TSG RAN Meeting #17
Biarritz, France, 3 - 6 September, 2002

RP-020604

Title CRs (R99 and Rel-4/Rel-5 Category A) to TS 25.433
Source TSG RAN WG3
Agenda Item 7.3.3

Title:	# Handling of conflicting specification text		
Source:	# RAN WG3		
Work item code:	# TEI	Date:	# 21/08/2002
Category:	# F	Release:	# R99
	Use <u>one</u> of the following categories:		Use <u>one</u> of the following releases:
	F (correction)		2 (GSM Phase 2)
	A (corresponds to a correction in an earlier release)		R96 (Release 1996)
	B (addition of feature),		R97 (Release 1997)
	C (functional modification of feature)		R98 (Release 1998)
	D (editorial modification)		R99 (Release 1999)
	Detailed explanations of the above categories can be found in 3GPP TR 21.900 .		Rel-4 (Release 4)
			Rel-5 (Release 5)
			Rel-6 (Release 6)

Figure 30: Synchronised Radio Link Reconfiguration Preparation procedure, Successful Operation

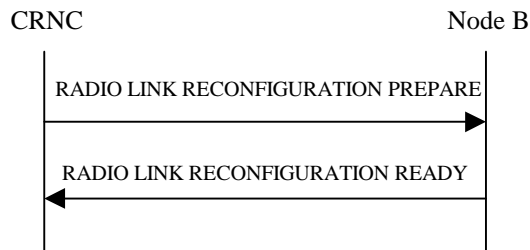
~~In the RADIO LINK RECONFIGURATION READY message, the Node B shall include the *RL Information Response* IE for each affected Radio Link.~~

The Node B shall include in the RADIO LINK RECONFIGURATION READY message the *Transport Layer Address* IE and the *Binding ID* IE ~~in the *DCH Information Response* IE~~ for any Transport Channel being added or any Transport Channel being modified for which a new transport bearer was requested with the *Transport Bearer Request Indicator* IE.

~~In case of a DCH requiring a new transport bearer on Iub, the *Transport Layer Address* IE and the *Binding ID* IE shall be included in the *IE DCH Information Response* IE.~~

Figure 34: Unsynchronised Radio Link Reconfiguration Procedure, Successful Operation

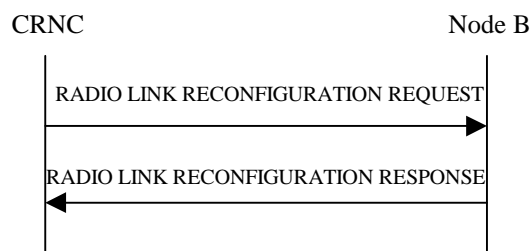
~~In the RADIO LINK RECONFIGURATION RESPONSE message, the Node B shall include the *RL Information Response* IE for each affected Radio Link.~~

The Node B shall include in the RADIO LINK RECONFIGURATION RESPONSE message the *Transport Layer Address* IE and the *Binding ID* IE ~~in the *DCH Information Response* IE~~ for any Transport Channel being added or any Transport Channel being modified for which a new transport bearer was requested with the *Transport Bearer Request Indicator* IE. The detailed frame protocol handling during transport bearer replacement is described in [16], subclause 5.10.1.

~~In the case of a Radio Link being combined with another Radio Link within the Node B, the *RL Information Response* IE shall be included only for one of the combined Radio Links. The *Transport Layer Address* IE and the *Binding ID* IE in the *DCH Information Response* IE shall be included only for one of the combined Radio Links.~~

Figure 30: Synchronised Radio Link Reconfiguration Preparation procedure, Successful Operation

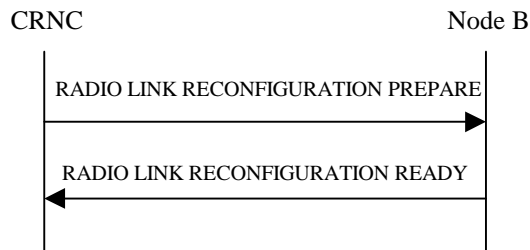
~~In the RADIO LINK RECONFIGURATION READY message, the Node B shall include the *RL Information Response* IE for each affected Radio Link.~~

The Node B shall include in the RADIO LINK RECONFIGURATION READY message the *Transport Layer Address* IE and the *Binding ID* IE ~~in the *DCH Information Response* IE~~ for any Transport Channel being added or any Transport Channel being modified for which a new transport bearer was requested with the *Transport Bearer Request Indicator* IE.

~~In case of a DCH requiring a new transport bearer on Iub, the *Transport Layer Address* IE and the *Binding ID* IE shall be included in the *DCH Information Response* IE.~~

~~In the case of a Radio Link being combined with another Radio Link within the Node B, the *RL Information Response* IE shall be included only for one of the combined RLs. The *Transport Layer Address* IE and the *Binding ID* IE in the *DCH Information Response* IE shall be included only for one of the combined Radio Links.~~

Figure 34: Unsynchronised Radio Link Reconfiguration Procedure, Successful Operation

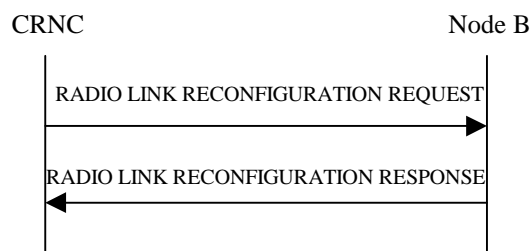
~~In the RADIO LINK RECONFIGURATION RESPONSE message, the Node B shall include the *RL Information Response* IE for each affected Radio Link.~~

The Node B shall include in the RADIO LINK RECONFIGURATION RESPONSE message the *Transport Layer Address* IE and the *Binding ID* IE ~~in the *DCH Information Response* IE~~ for any Transport Channel being added or any Transport Channel being modified for which a new transport bearer was requested with the *Transport Bearer Request Indicator* IE. The detailed frame protocol handling during transport bearer replacement is described in [16], subclause 5.10.1.

~~In the case of a Radio Link being combined with another Radio Link within the Node B, the *RL Information Response* IE shall be included only for one of the combined Radio Links. The *Transport Layer Address* IE and the *Binding ID* IE in the *DCH Information Response* IE shall be included only for one of the combined Radio Links.~~
